# CITY OF CARMEL-BY-THE-SEA HISTORIC RESOURCES BOARD AGENDA

**Regular Meeting**  
**Monday, August 18, 2025**  
**4:00 PM**

**TO:** Historic Resources Board Members  
**SUBMITTED** Katherine Wallace, Associate Planner  
**BY:**  
**SUBJECT:** **HE 25120 (Profeta):** Consideration of a preliminary determination of historic ineligibility for the property located on the west side of Junipero between 5th and 6th Avenues. APN: 010-098-005 and 010-098-006.

**TO:** Historic Resources Board Members  
**SUBMITTED BY:** Katherine Wallace, Associate Planner  
**BY:**  
**SUBJECT:** **DR 25181 (Carmel Mission Basilica):** Consideration of a Determination of Consistency with the Secretary of the Interior's Standards for accessibility upgrades at the historic "Mission San Carlos de Borromeo" located at 3080 Rio Road in the Single-Family Residential (R-1) District, Archaeological Significance Overlay, Park Overlay and Beach & Riparian Overlay districts. APN: 009-531-003-000.

Figure 3: Proposed accessible path of travel diagram.

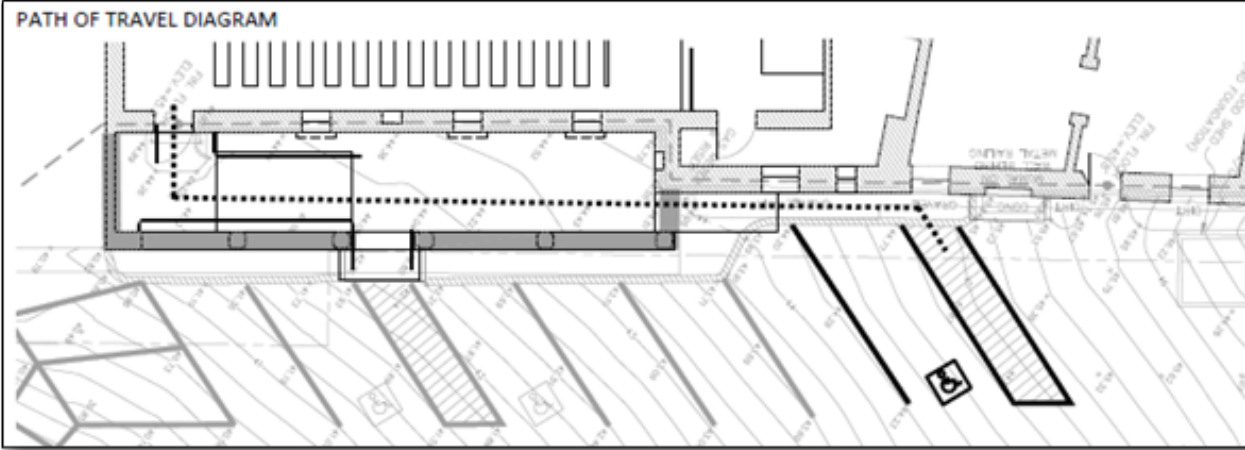
Design drawings by Architectural Resources Group, dated June 4, 2025 were evaluated for this Focused Phase Two Historic Assessment. Specifically, the project will:

- Install a new accessible parking stall and path to a new sloped walkway to the loggia level;
- Construct a new concrete ramp with steel handrails, to replace the existing non-historic stair at the entrance to the Blessed Sacrament Chapel;
- Relocate the existing Blessed Sacrament Chapel door within the existing opening, closer to the exterior face of the wall to provide accessibility clearances; and
- Reconfigure the existing door hardware to meet current accessibility requirements for type and mounting height.
